STAFF REPORT

SUBJECT: **Case #20-15 - 19 Hathaway Road - Thomson Antique World**

Approve an application by Thomson Antique World for Site Plan Review for the use of a weekend flea market in the existing parking lot of the former Building 19, located at 19 Hathaway Road (Map 101, Lot 8), in the Industrial - B zoning district (Attachment 1).

SITE PLAN
19 HATHAWAY ROAD
ASSASSOR MAP 101 LOT 8
NEW BEDFORD, MASSACHUSETTS

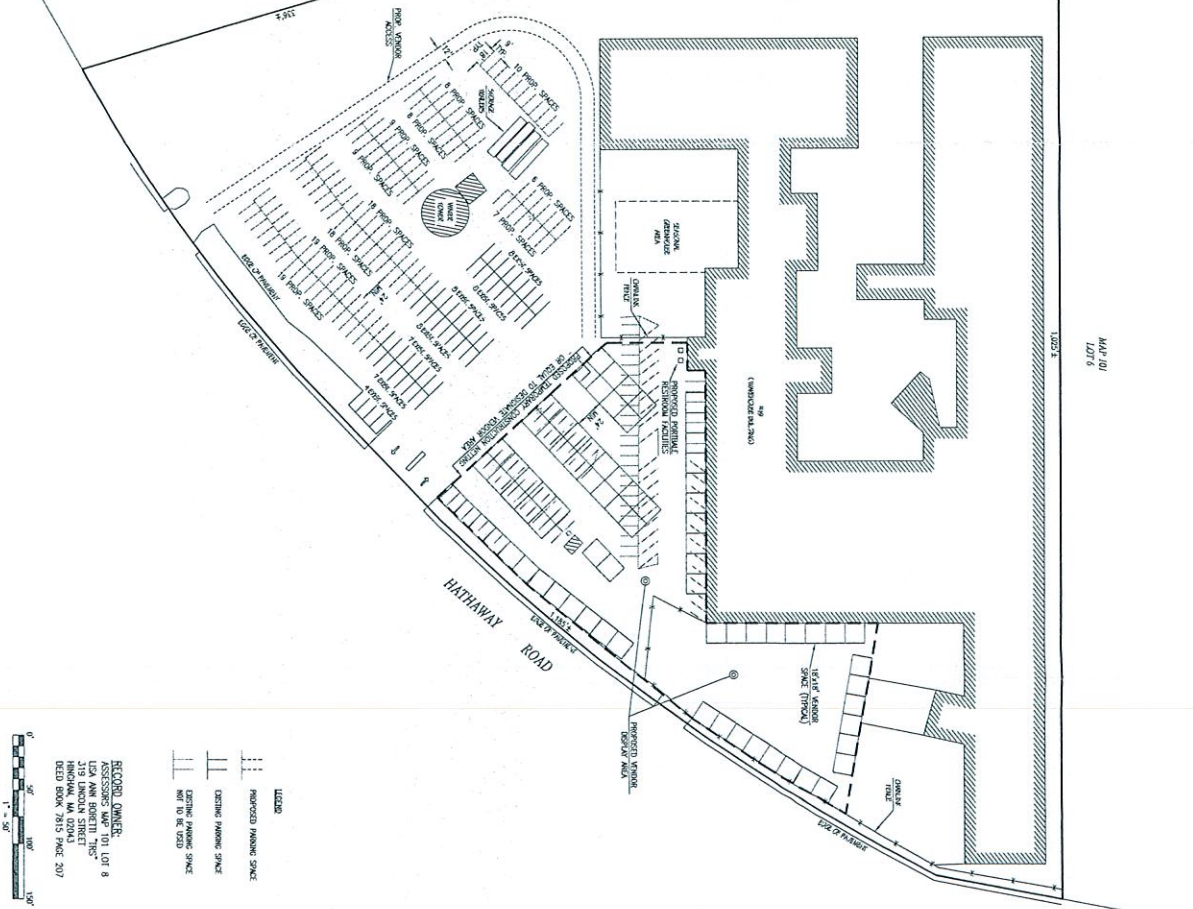
The Trustee is Robert Walsh, who may be found named at Deed Book 10506 and Page 111. The Site Plan should be revised to reflect this information (Attachment 3).

Technical review of plans finds the following: 1. The submitted site plan does not show handicap parking availability. 2. The site plan does not show onsite parking circulation. 3. Parking dimensions noted on the plan submittal are stated as 9' x 18'.

Internal circulation of the site is not illustrated on the plan. Under section **5479A**, *the proposal should promote orderly and reasonable internal circulation within the site so as to protect public safety and not unreasonably interfere with access to a public way or circulation of traffic on a public way in general*. The

Section 3150 stipulates, "A parking space shall be a rectangle of at least nine feet by twenty feet exclusive of any required drive or aisle of the parking space". The site plan shows a typical parking space dimension of nine (9) feet by eighteen (18) feet. The plan illustrates 24 feet between parking aisles; under **Section 3144**, "Where a drive or aisle, other than a street, is required to maneuver a vehicle into or out of a parking space, such drive or aisle shall be at least twenty-two (22) feet wide for parking spaces situated at right angles, or nearly right angles to the aisle".

The applicant should accurately revise the site plan to comply with the above described City ordinance parking requirements.

An On the Ground instrument survey was not performed to produce this plan.

The deed of owner is incorrectly noted on the plan. Recorded Trustee is Robert Walsh. Documentation supporting this change was provided to the Planning Division office by Attorney Norman Greenberg (233 Needham Street, Suite 500, Needham, MA 02464). The plan should be updated to reflect this correction. The Assessor's Office has been notified, as assessor's information reflects the previous trustee, Lisa Boretti.

Landscaping is not shown on the single plan sheet. Section **5451.e.** of Site Plan Review requires that a Landscaping plan be submitted, showing the limits of work, existing tree lines as well as those tree lines to remain, and all proposed landscape features and improvements including screening, planting areas with size and type of stock for each shrub or tree. The applicant is reminded to review **Section 3146** directs the applicant to refer to **Section 3300** for additional site plan review stipulations for screening and landscaping.

Internal circulation of the site is not shown on the plan. Under section **5479A**, the proposal should *promote orderly and reasonable internal circulation within the site so as to protect public safety and not unreasonably interfere with access to a public way or circulation of traffic on a public way in general.*

The case submittal was presented without a topo or drainage plan of existing conditions. Site plan review stipulates requirements for such plans under section **5451.b.** *(Topography and drainage plan, which shall contain the existing and proposed final topography at two-foot intervals and plans for handling stormwater runoff drainage.)*

No description of utility service was shown on the plan. (5451.c. *Utility plan, which shall include all facilities for refuse and sewerage disposal or storage of all these wastes, the location of all hydrants, fire alarm and firefighting facilities on and adjacent to the site...*)

Two portable toilets are noted on the plan. The applicant should consult with City of New Bedford Health Director Brenda Weiss for her professional opinion regarding the minimum of portable toilets required to serve the customer base of 200-330+/- people per day.

- The site line is obstructed by overgrown vegetation from the ingress and egress points and should be trimmed for safety reasons. (5472. Maximize: pedestrian and vehicular safety to and from the site.)
- Existing landscaping is overgrown.
- The parking lot pavement is poorly maintained in extensive areas. For safety reasons, the applicant should remove the weed growth, and patch and repair the damaged pavement.
- The valve system for the water holding tank is not shown on the plan and may interfere with the parking layout.
- The valve system structure should be noted on the revised plan submittal.

- Revise the plan to accurately note the current owner of record.
- Existing landscaping is not shown on the site plan.
- No landscaping plan has been provided.

- The submitted site plan does not show handicap parking availability.
- The site line is obstructed by overgrown vegetation from the ingress and egress points and should be trimmed for safety reasons.

- The applicant should accurately revise the site plan to comply with the City ordinance parking location and layout requirements.
- The existing structure may interfere with the parking layout. This structure should be noted in the revised plan.
